Item 4.**Section 4.55 Application: 499-501 Kent Street, Sydney - D/2020/1224/A**

File No.: D/2020/1224/A

Summary Recommendation: The subject section 4.55(2) modification application is recommended for approval.

Figure 12: Proposed indicative demolition - heritage elevations (removal of non-original fabric)

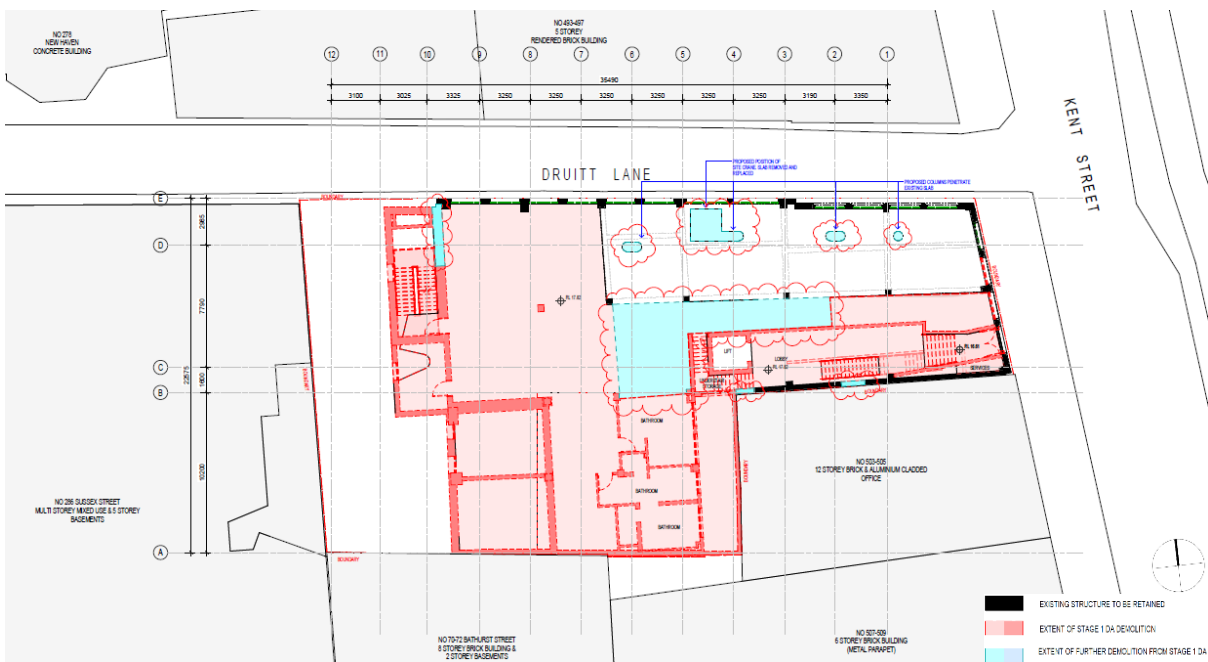
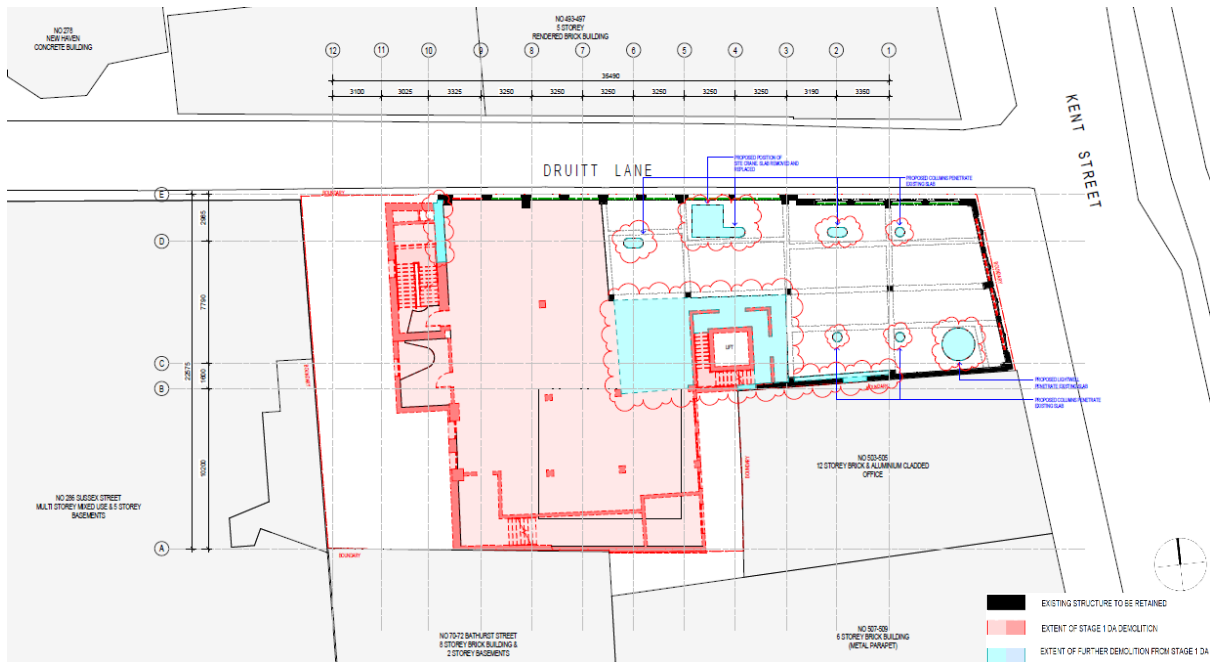
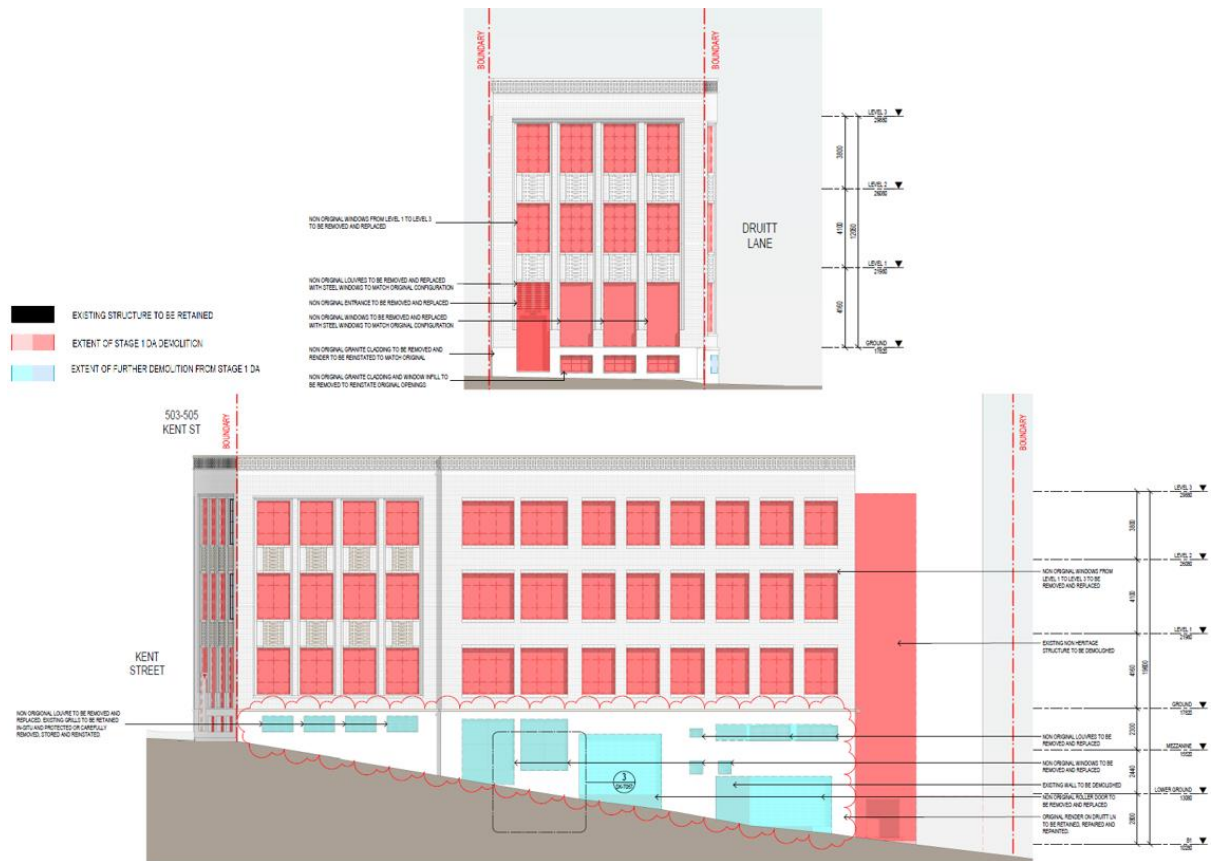
69. The proposed modification to Condition (12)(a) is to allow additional indicative demolition of the following elements, as shown in Figures 7-10, and 12 above:
 - (a) sections of internal floor slabs;
 - (b) cutouts in internal floor slabs to accommodate a temporary construction crane, new structural columns for the hotel tower, and new skylights;

72. On the other hand, the additional cutouts in the upper-level floor slabs are required to accommodate new structural columns for the new tower addition, new skylights, and a temporary construction crane. The new structural columns will independently support the new tower addition to avoid potential impacts (including alterations) on the existing steel columns and structural integrity of the heritage item, while the skylights will provide the heritage item improved access to natural light. The temporary construction crane is also necessary to facilitate the construction of the Detailed Design DA, given the constraints of the site and its surrounds.

73. Similarly, the proposed additional demolition to the Druitt Lane lower ground level facade is to alter the existing openings and replace non-original windows and roller doors to accommodate the new lower ground level entrance and new services, including water meter and fire-hydrant booster chamber.

74. The interior of the heritage building has been substantially modified and replaced. As such, the heritage significance of the building is largely confined to the external form of the building. In particular, the floor slab and the openings on the Druitt Street facade are identified to have little heritage significance. Their removal and modifications are therefore considered acceptable by the submitted heritage impact statement and the City's Heritage Specialist, and will not detrimentally impact on the significance of the heritage item.

- (a) The Stage 2 DA must retain all the building facades and structural elements specified for retention in the stage 1 DA **with the exception of internal floor slab, columns, facades elements and walls as shown in the drawings prepared by SJB and referenced under Condition (2) above**. No additional demolition or a change to existing facades except for conservation works is allowed.

Figure 13: Approved (left) and proposed (right) concept envelope sections

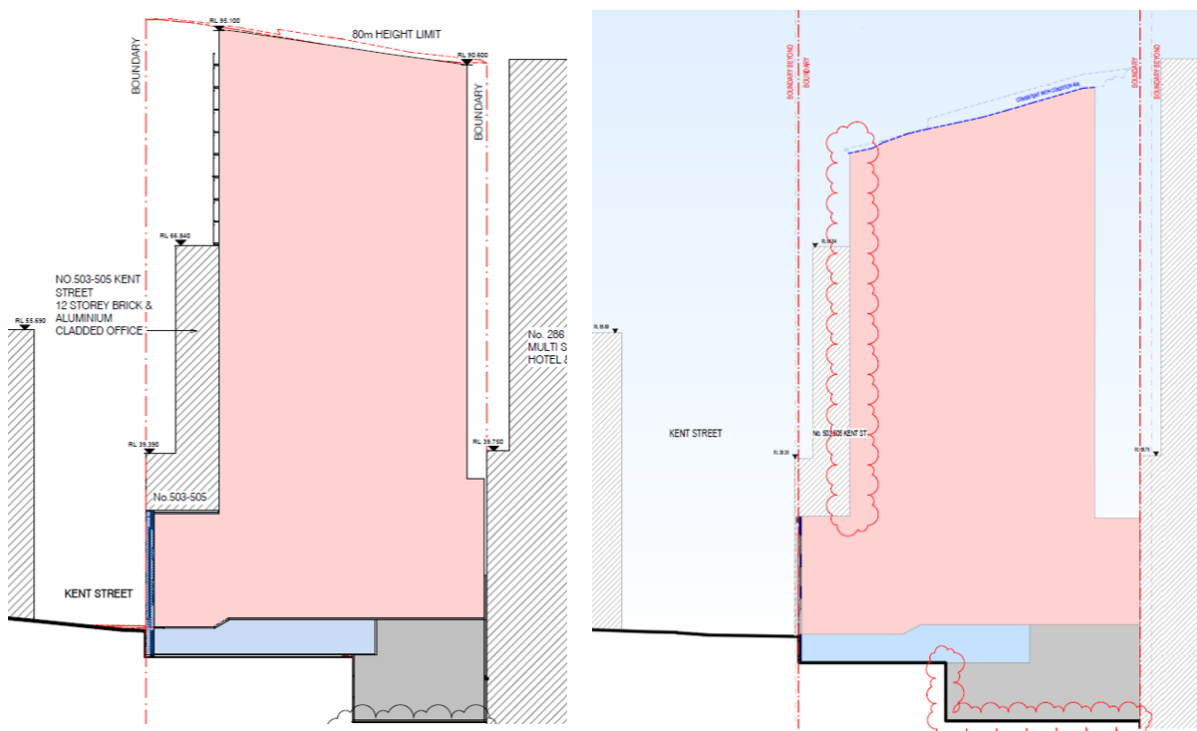
31. The concept envelope, as shown in the approved envelope drawings reflects the maximum 80 metre height plane.
32. Condition (4)(a) was modified by the CSPC at its 25 March 2021 meeting to bring into effect a requirement of the then approved Planning Proposal - Central Sydney 2020 to preserve sun access to the future Town Hall Square between 12pm midday and sunset throughout the year.

33. The concept envelope, however, was not amended to reflect the requirements of Condition (4)(a). Under the assumption that the approved concept envelope automatically satisfies the requirement of Condition (4)(a), the competitive design process and the preparation of the concurrent Detailed Design DA were not informed of the need to amend the concept envelope.

34. Following detailed solar analyses carried out by the project architect SJB, and verified by the City's Model Unit, a site-specific sun access plane is established. The highest point is in the west, established by the existing parapet height of the adjoining development at 60 Bathurst Street, and the lowest point is in the east at the Kent Street frontage. As illustrated in Figure 13 below, the sun access plane runs in the opposite direction to the maximum 80m height plane.
35. It is recommended that Condition (2) be amended to reference the updated concept envelope drawings. This is to reduce the overall height of the concept envelope, reflecting the site-specific sun access plane. This ensures any future detailed design development that is wholly contained within the envelope will entirely preserve sun access to the future Town Hall Square.

The height of the tower envelope must not exceed RL 95.600 (AHD) and must not cause additional overshadowing to the Future Town Hall Square, between 12 noon and sunset all year, in accordance with the approved Planning Proposal – Central Sydney 2020.

Figure 14: Comparison of the approved (left) and proposed (right) concept envelope

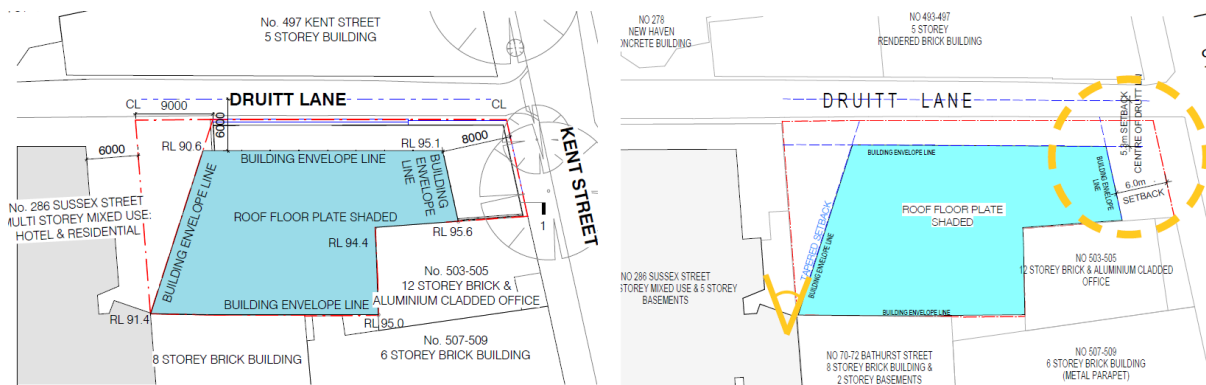
37. It is proposed to reduce the Kent Street tower setback by 2m, from 8m to 6m, as shown in Figure 14 below. The proposed reduction is made in association with the proposed reduction in the overall building height, which is to preserve sun access for the future Town Hall Square as discussed above. The proposed reduction is to enable the redistribution of floor space, ensuring the concept envelope can reasonably accommodate the permissible floor space to support a feasible development scheme.

40. The proposed 6m setback is acceptable in the above context and is consistent with the objectives of Section 5.1.1.1 of Sydney DCP 2012 for street frontage height and street setbacks, considering:

- (a) the concept envelope as modified will maintain a three storey street wall that maintains the variety of street wall heights along the western side of Kent Street;

- (b) the new tower, with the proposed 6 metre setback, will maintain a stepped relationship with the adjoining tower at 503-505 Kent Street as shown in Figure 16 above, similar to the relationship between 511-513 and 515 Kent Street;

- (c) the new tower, being set back further than 503-505 Kent Street and the 10 storey building at 483-491 Kent Street, will also maintain long views of open sky, especially considering the overall envelope height is also being reduced;

- (d) the reduced setback will ensure an acceptable stepped relationship between the existing building at 503-505 Kent Street, which is setback approximately 3m from Kent Street, and any future tower envelope above 493-497 Kent Street, which is required to have an 8m setback to Kent Street;

- (e) given the orientation of Kent Street, and the lower street wall height and overall building heights on the eastern side, the proposed 6m tower setback will maintain adequate daylight access and a sense of openness to Kent Street;

Figure 15: Western side of Kent Street viewed from Bathurst Street, facing north, illustrating the varying street wall height and upper-level setback within the street block

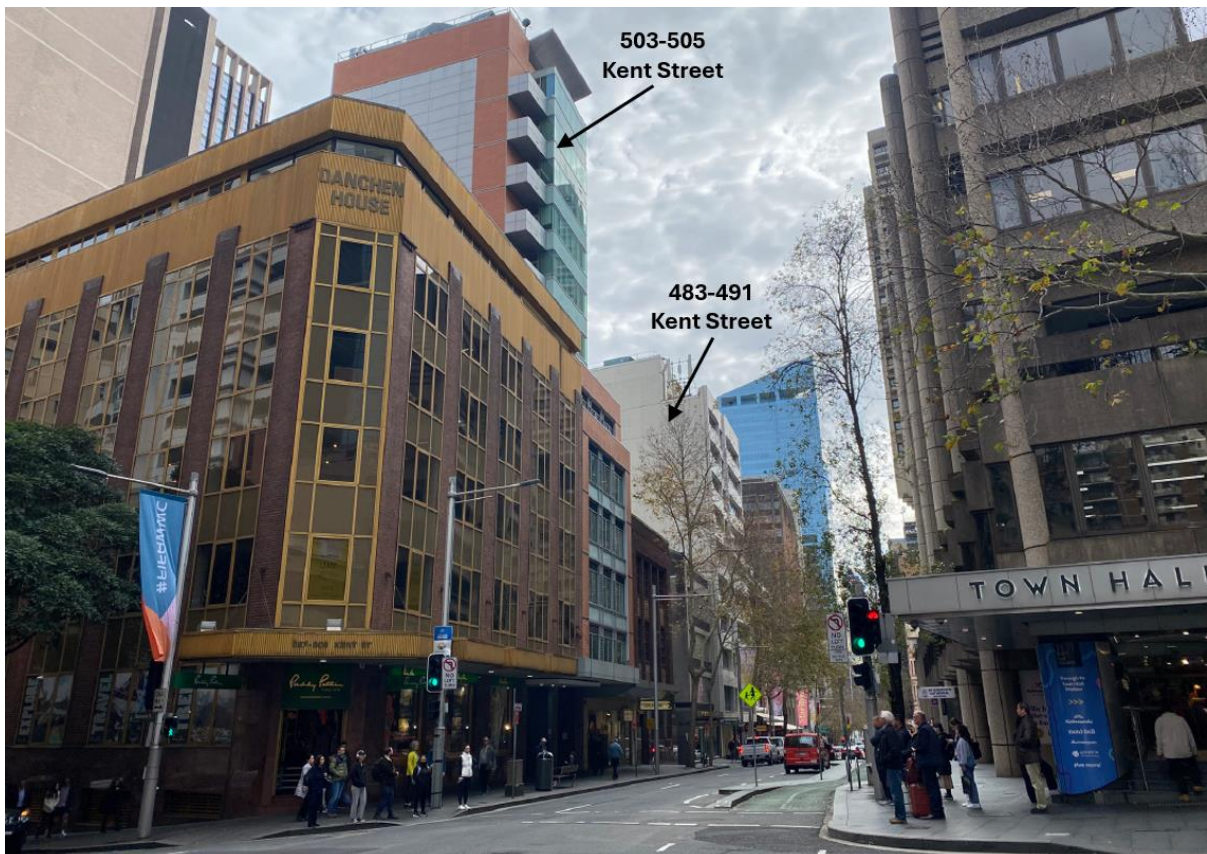
38. In the wider context, the western side of Kent Street, as perceivable together with the subject site, has a varying street wall height and upper-level setback as detailed below:

- (a) the existing carpark building at 521-527 Kent Street has a seven storey street wall, with no existing/approved/concept envelope for a tower addition above;
- (b) the existing Maestri Towers at 515 Kent Street has a seven storey street wall, with a tower addition above that is set back 2.5 metres in the north, corresponding to the Adina hotel, and an increased 3 metre setback in the south;
- (c) the existing Adina hotel building at 511-513 Kent Street has a stepped street wall height of seven storeys to 10 storeys, with a tower addition that is minimal setback at the street corner and an increased setback of approximately 2.5 metres in the south;
- (d) the existing building at 507-509 Kent Street has a six storey street wall, with no existing/approved/concept envelope for a tower addition above;

- (e) the existing building at 503-505 Kent Street has a six storey street wall, with a tower addition above that is setback between 4.4 to 5.2 metres, with 'glass enclosed projections' on the Kent Street facade that are setback between 3 to 3.7 metres;
 - (f) the existing building at 493-497 Kent Street has a four storey street wall (but same height as the subject site), with no existing/approved/concept envelope for a tower addition above;
 - (g) the existing building at 483-491 Kent Street has a 10 storey street wall, with two additional storeys that are setback approximately 3 metres; and
 - (h) the existing buildings at 465-481 Kent Street have a stepped street wall height of five storeys to two storeys, stepping down to the north.
39. The varying height and setbacks within the wider context are also illustrated in Figures 15 and 16 below.

Figure 18: Sun's eye diagrams - demonstrating at least 2 hours of direct sunlight to balconies of the eastern apartments of 60 Bathurst Street (same level as previously approved)

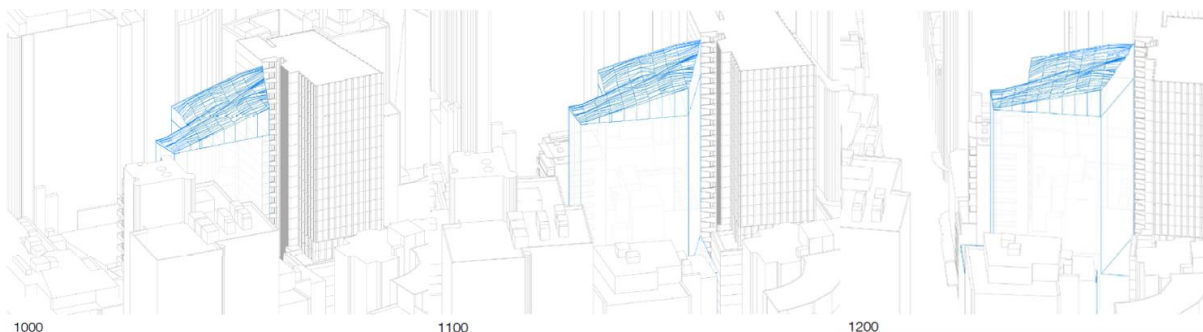
46. The reduced setback will not result in additional amenity impacts to the adjoining residential development at 60 Bathurst Street. This is achieved primarily by maintaining the approved tapered western setback (discussed separately below), which allows:
- (a) the same level of solar access, being over two hours of direct sunlight in mid-winter to be maintained to the balconies of the eastern apartments of the adjoining 60 Bathurst Street, as shown in Figure 18 below:
 - (b) the same level of outlook as shown in Figure 19 below.

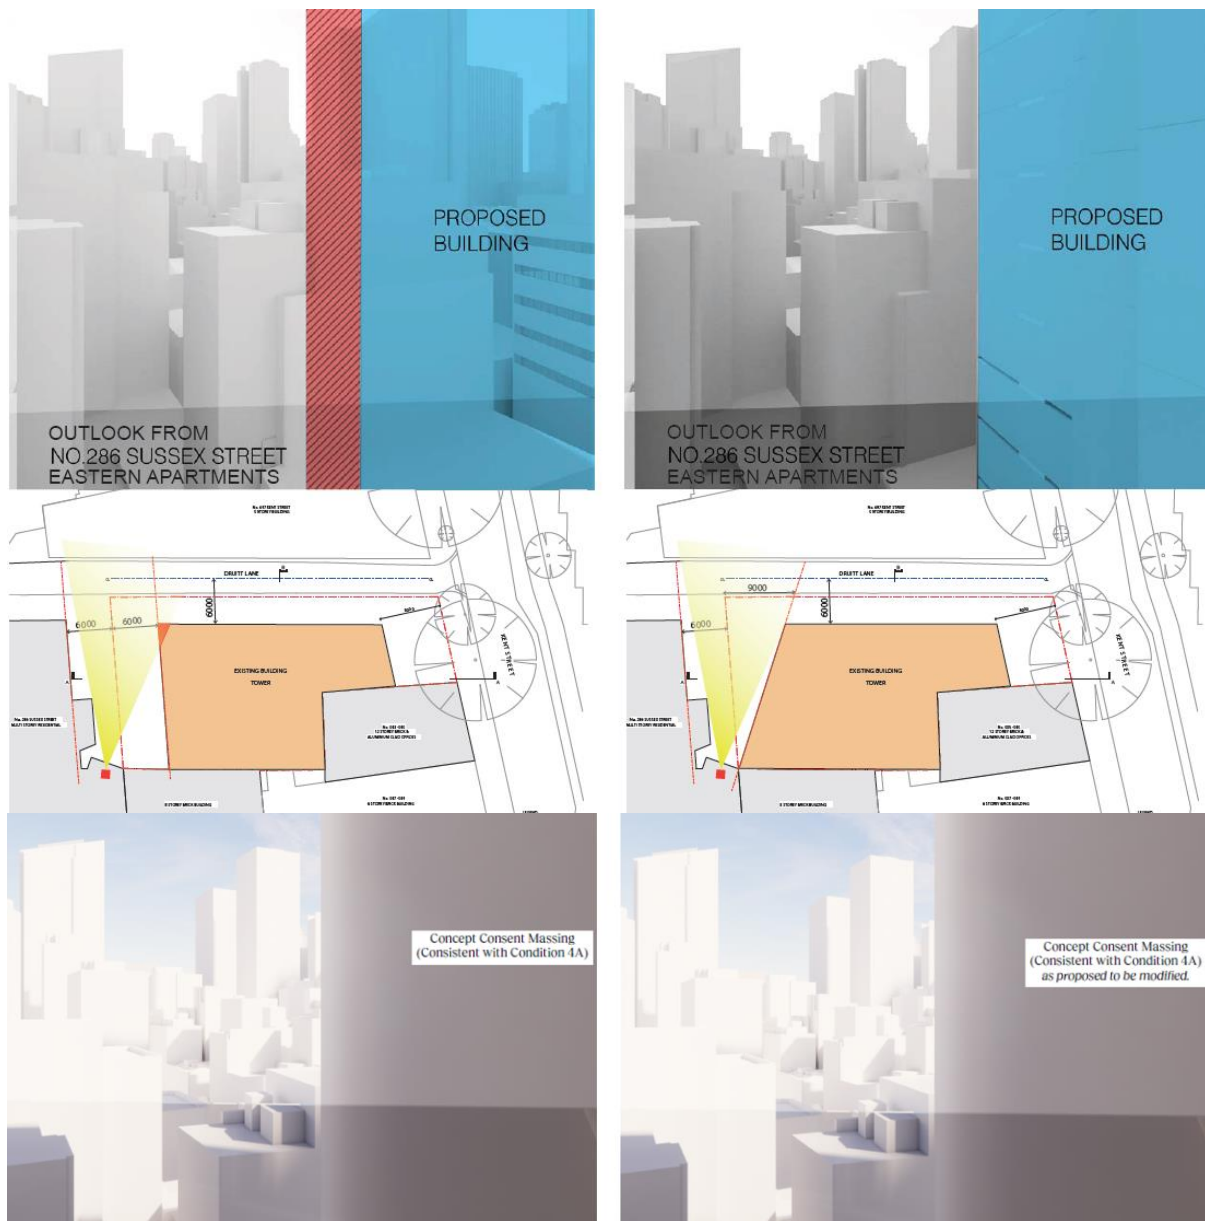
49. The comparison diagrams included in the assessment report of the concept consent is reproduced in Figure 19 above for reference. Demonstrating the improved outcome for the eastern apartments of the adjoining 60 Bathurst Street.

Figure 20: Comparison of the approved lower ground and ground levels footprint in blue and that of the concurrent Detailed Design DA

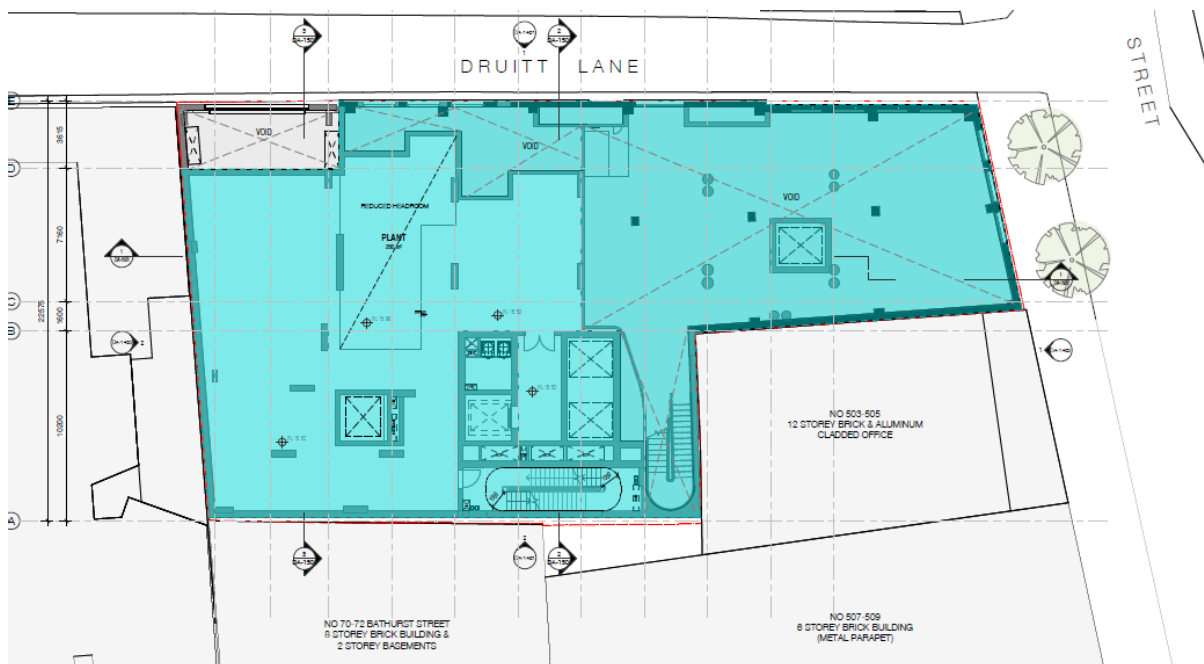
50. It is proposed to increase the concept envelope on the lower ground and ground levels by infilling the northeastern void setback, as shown in Figure 20 below.

52. Furthermore, the additional envelope will conceal the future driveway to the site, it will also provide for a more consistent street wall to the southern side of DrUITT Lane. As demonstrated by the concurrent Detailed Design DA, any addition located within the envelope can also adopt a different architectural character to clearly present as a new addition while responding to the nuance detailing of the heritage item.

53. Therefore, the additional envelope is acceptable, as it can support an improved design outcome. While preserving the aesthetic or historical significance of the heritage item.

Figure 22: Indicative encroachments into tree protection zones and crowns (source: Arboricultural Impact Assessment by Arboreport)

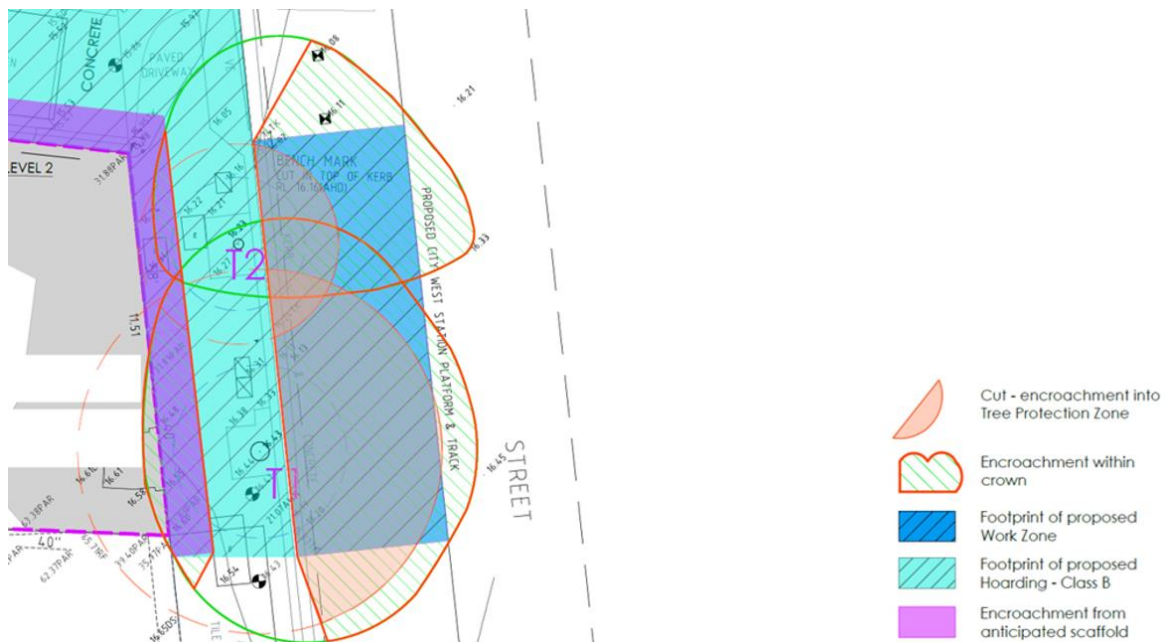
82. An arborist report is submitted to support the Detailed Design DA, which identifies the class B hoarding, scaffolding and construction work zone would result in over 40 per cent encroachments into the tree protection zones, and over 60 per cent encroachment into the trees' crowns, as shown in Figure 22 below. The construction work zone, and the transport of building materials over the Kent Street footpath and the existing heritage facade, would also result in substantial pruning of the existing street trees.

83. The arborist report concludes that the substantial encroachments and pruning would severely affect the long-term health of the two existing street trees even if they are retained. Therefore, it is recommended that the two existing street trees be removed, and two replacement trees be provided as part of the Detail Design DA's public domain works.
